ADDENDUM NO. 02

Project:
Sheridan HS and MS School Renovation Project

Owner:
Sheridan Community Schools
24795 Hinesley Road
Sheridan

This Addendum #02, Dated 09.12.2025, forms part of the contract documents and modifies the original Bidding Documents dated 08.15.2025. Please acknowledge receipt of this Addendum in the space provided on the Bid Form. Failure to acknowledge this Addendum may subject the Bidder to disqualification.

DRAWING NUMBER
ED201A

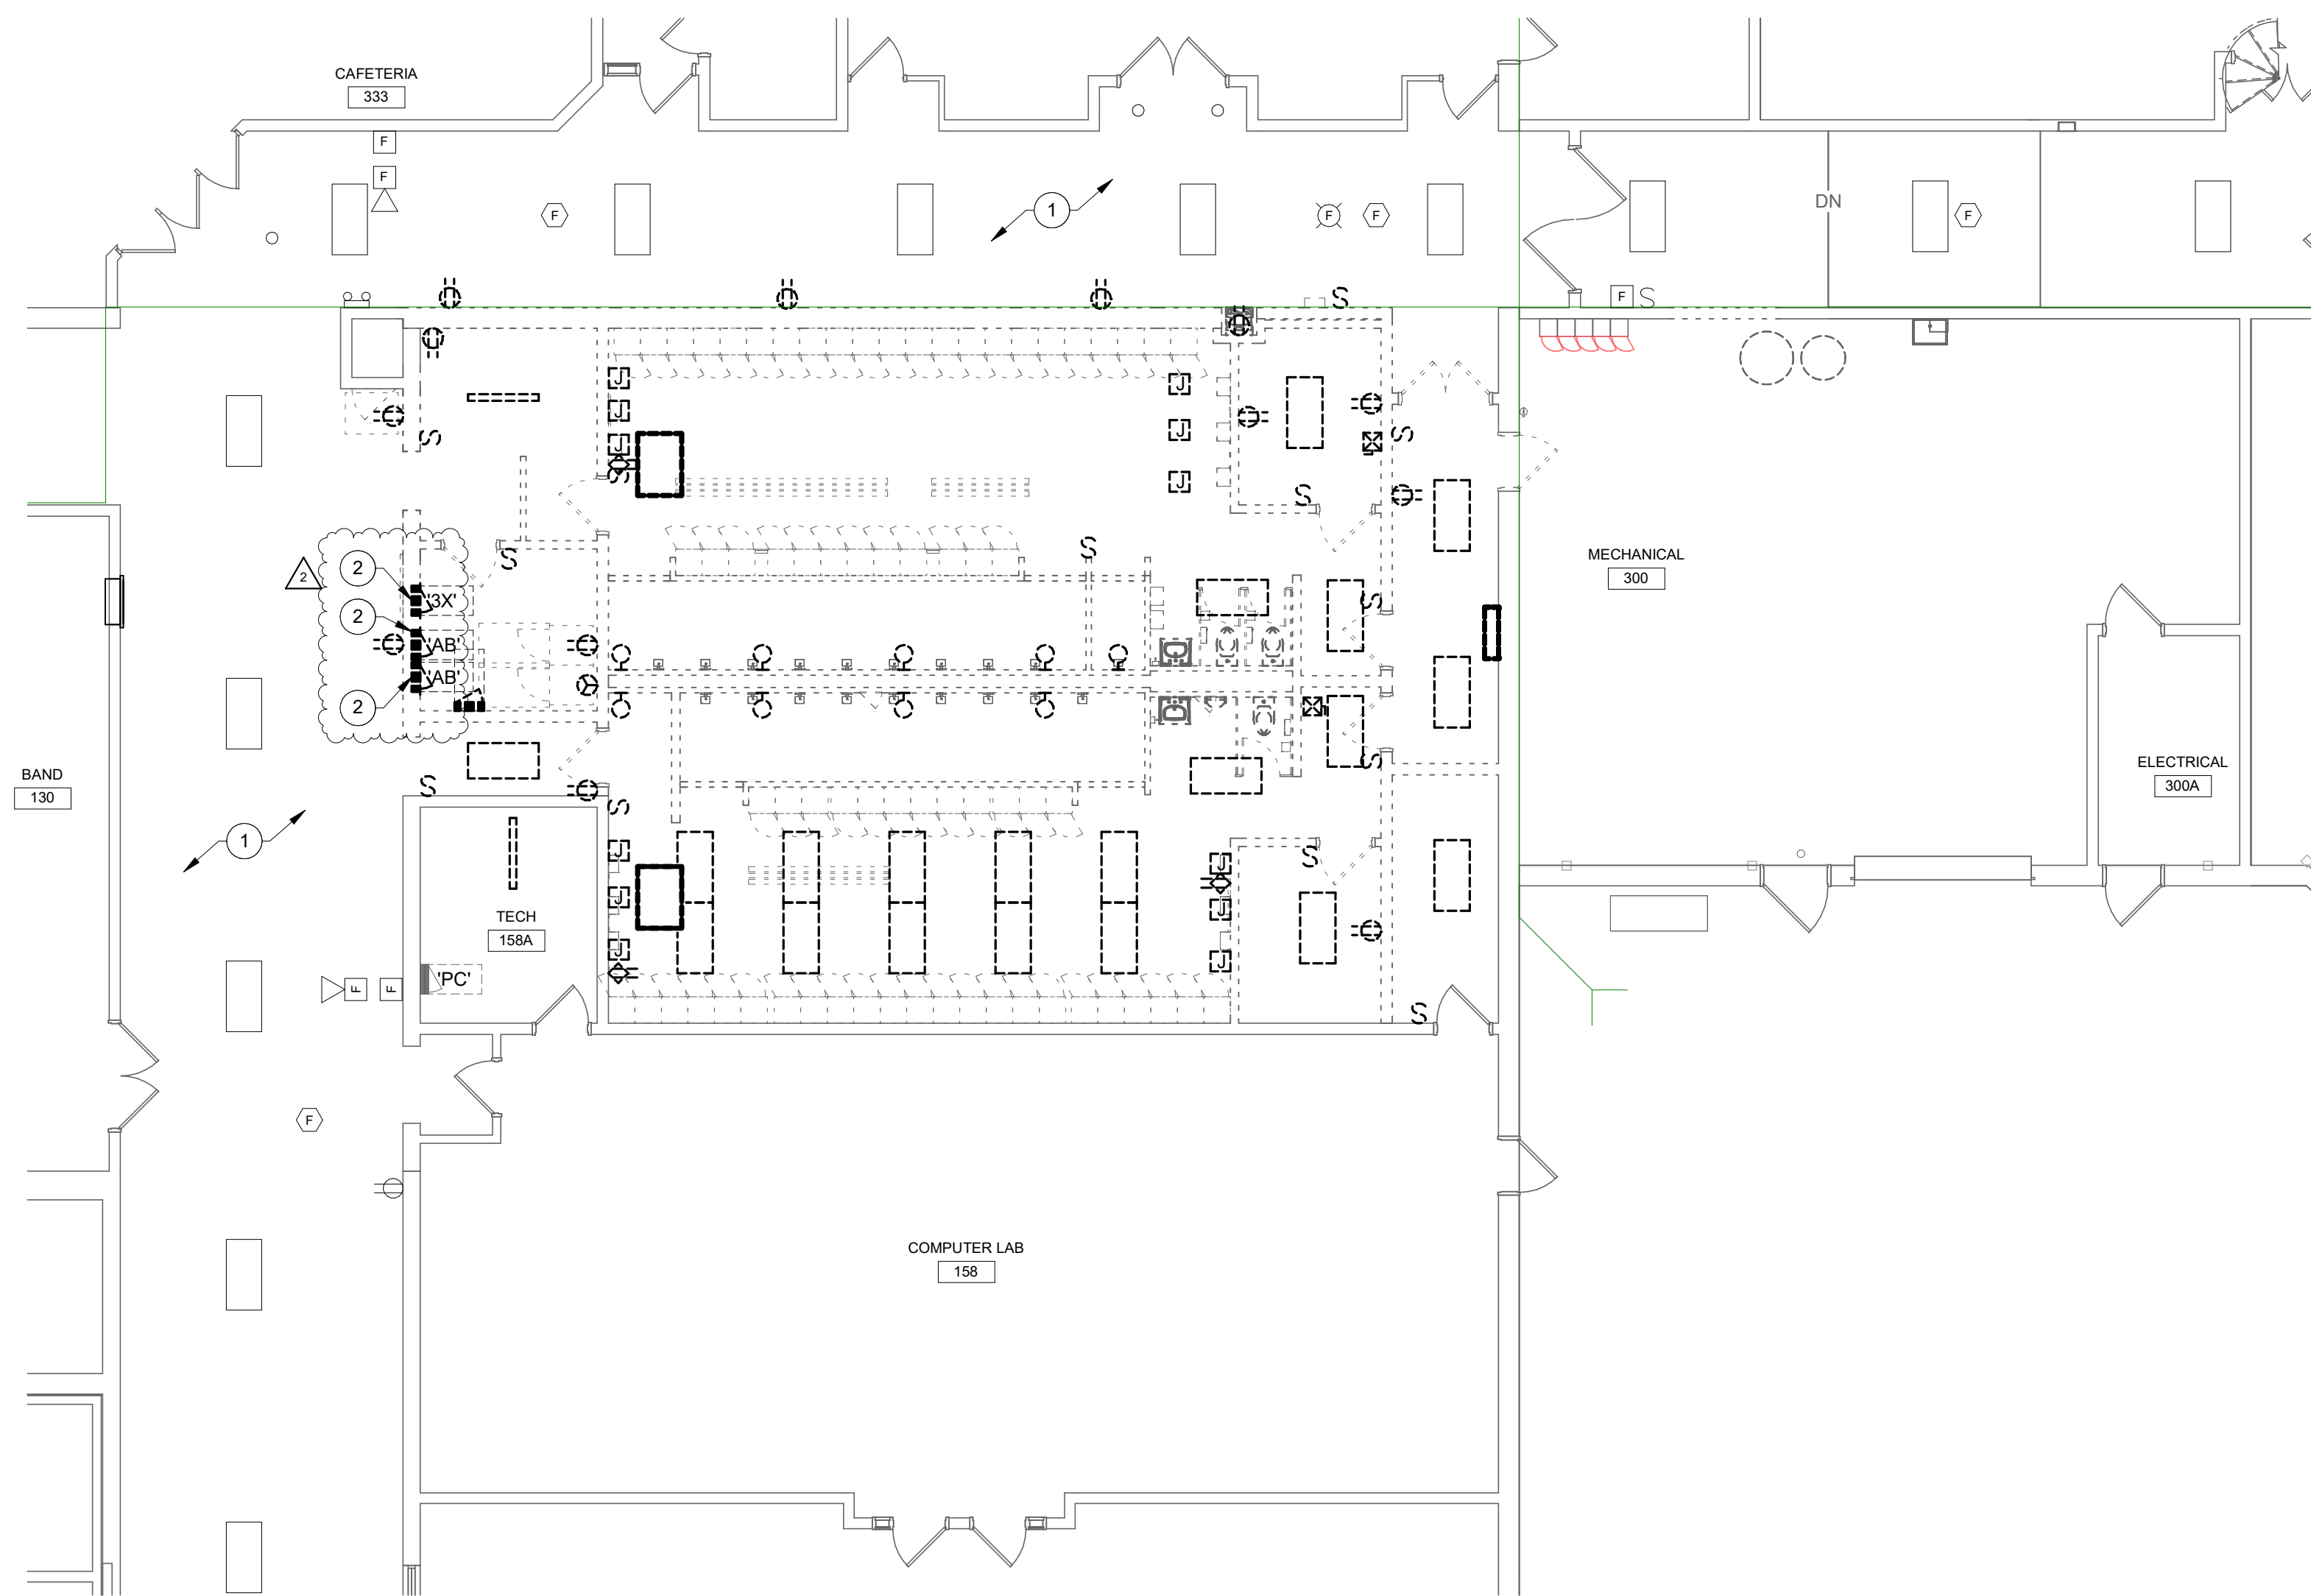
- A. Edited Plan Notes on Drawing.
- B. This drawing is to be reissued in its entirety.

12. Bid Item #14 Electrical Contractor shall be responsible for salvaging the existing VFD per Plan Note 7 on Drawing MD201D.
13. Bid Item #14 Electrical Contractor shall be responsible for Plan Note 2 on Drawing ED201A. Note this might require some temporary electrical work to keep the building live until you install the new circuits and panels.

DRAWING TITLE:
GROUND FLOOR
PLAN - UNIT B
ELECTRICAL
DEMOLITION

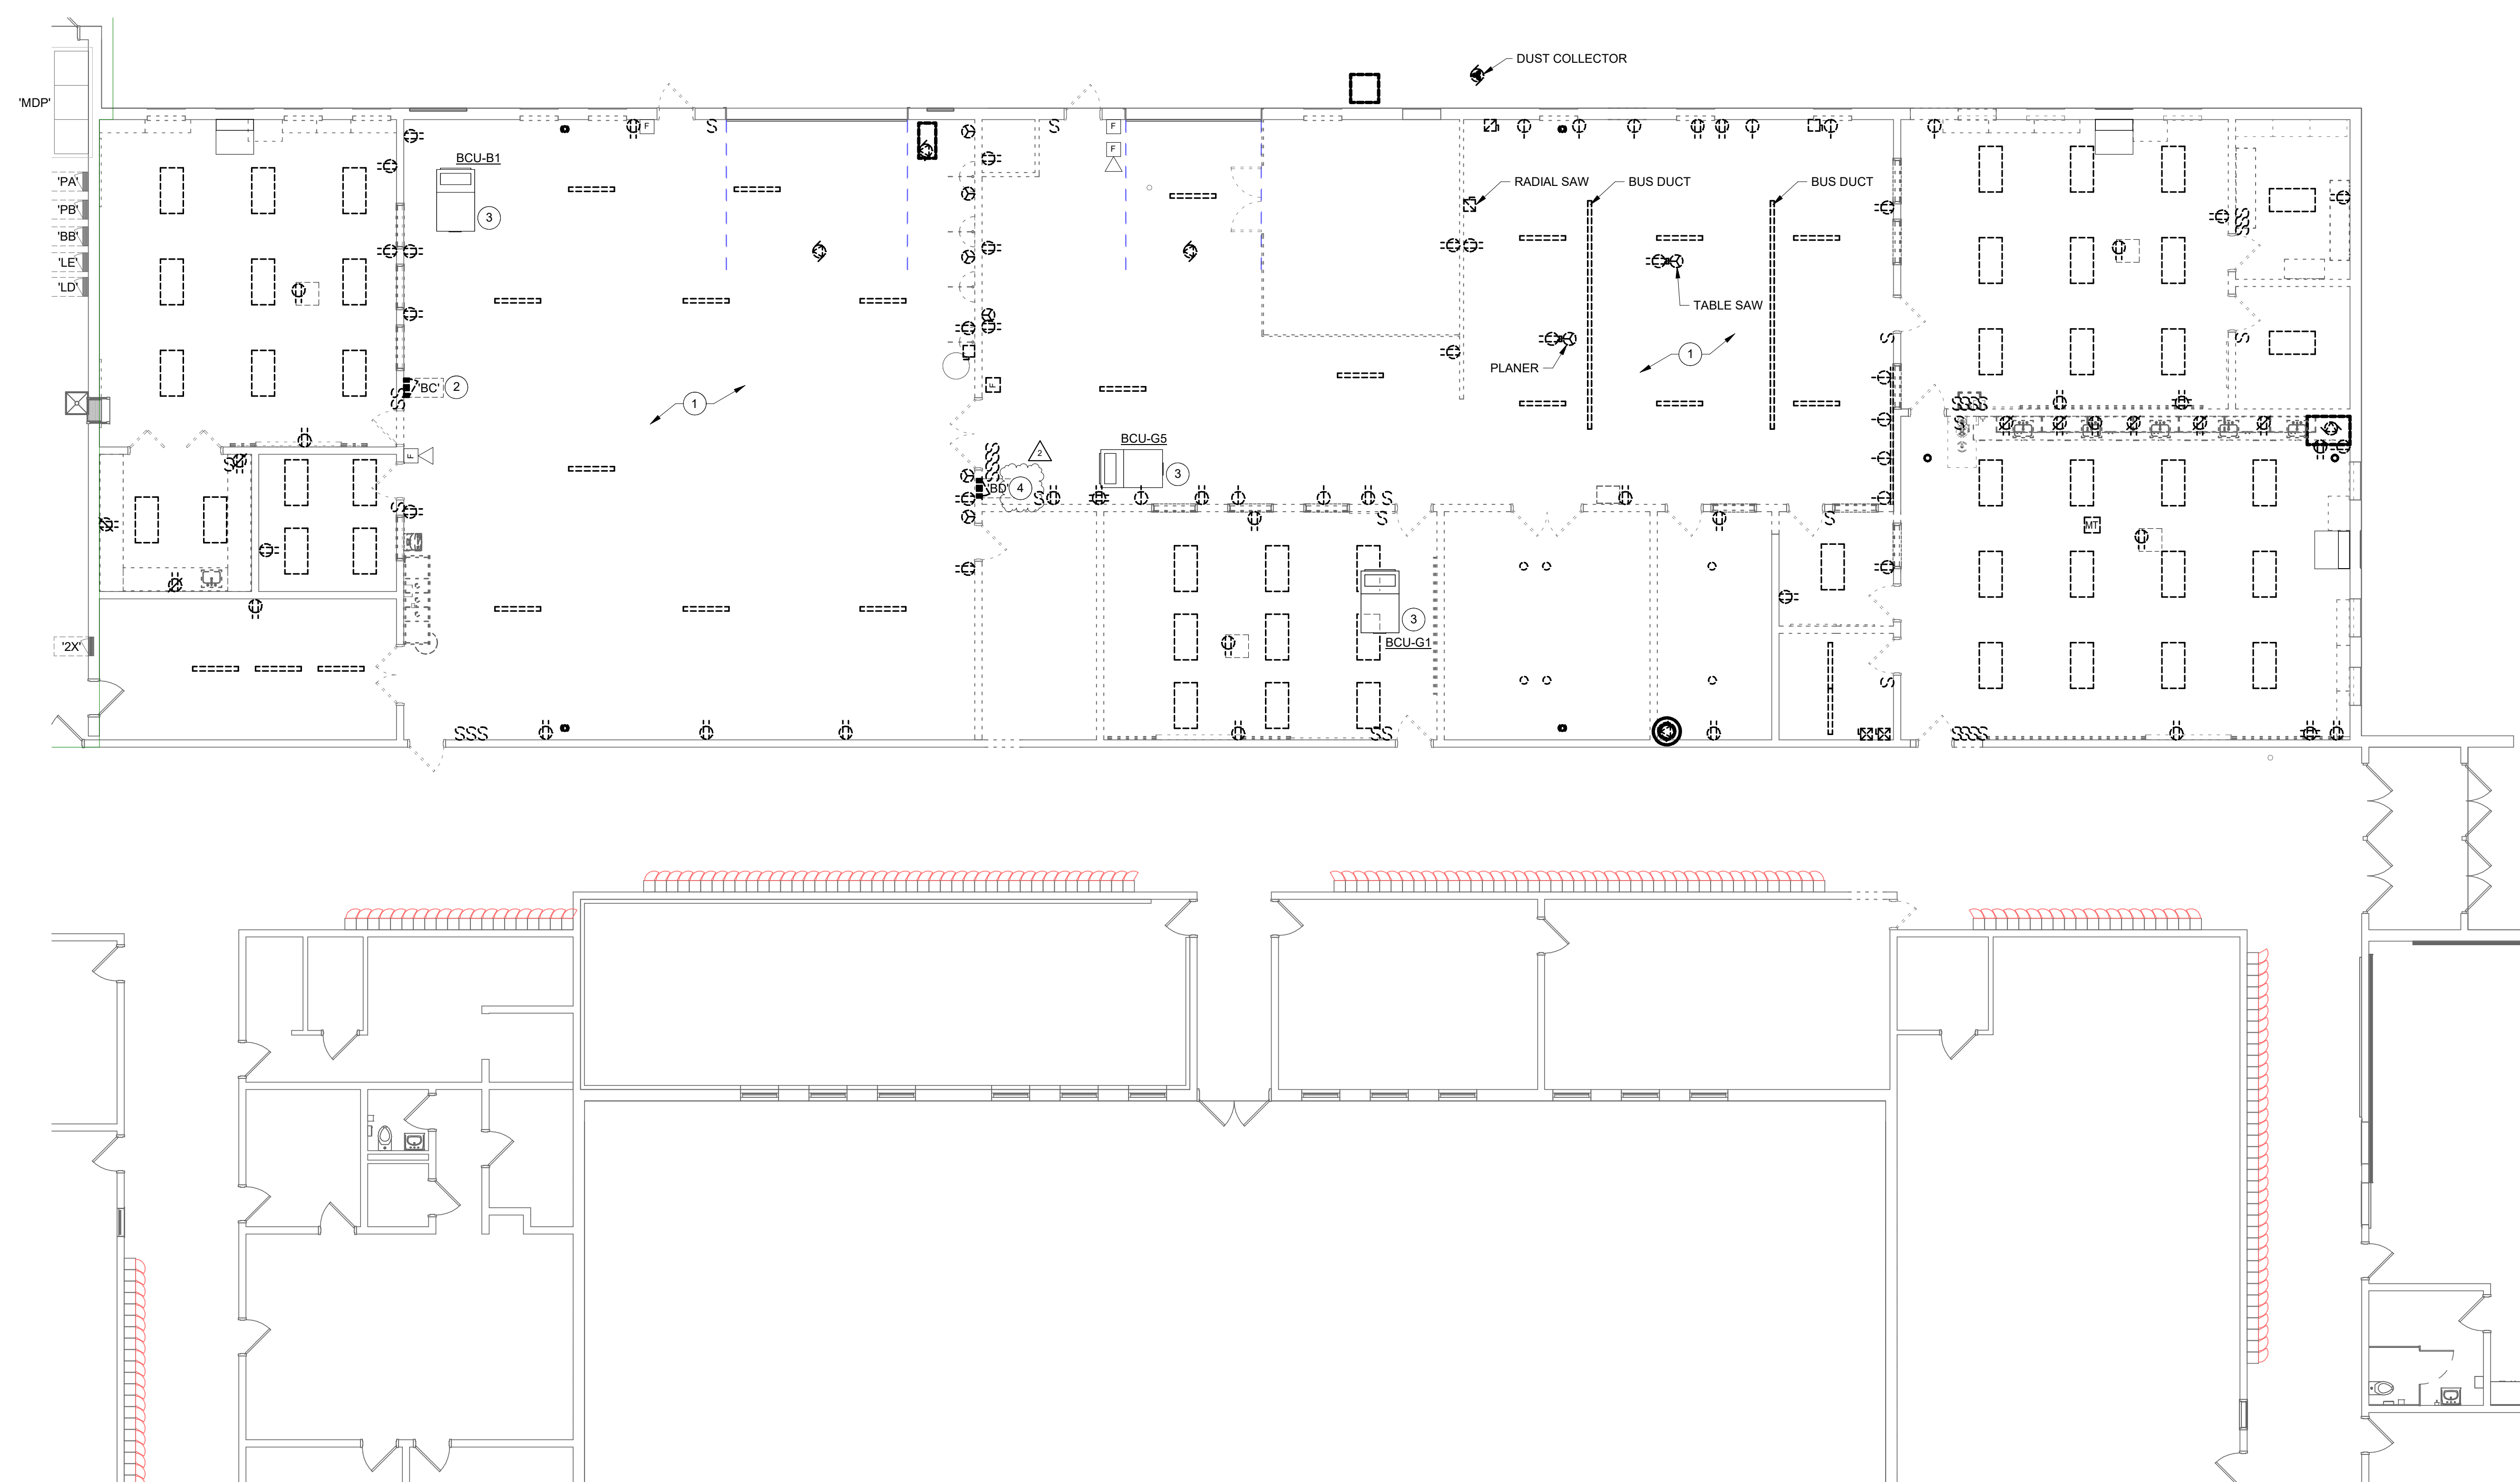
- A. Added Plan Note 4.
- B. This drawing is to be reissued in its entirety.

14. Bid Item #14 Electrical Contractor shall be responsible for Plan Note 4 on Drawing ED201B. Note this might require some temporary electrical work to keep the building live until you install the new circuits and panels.
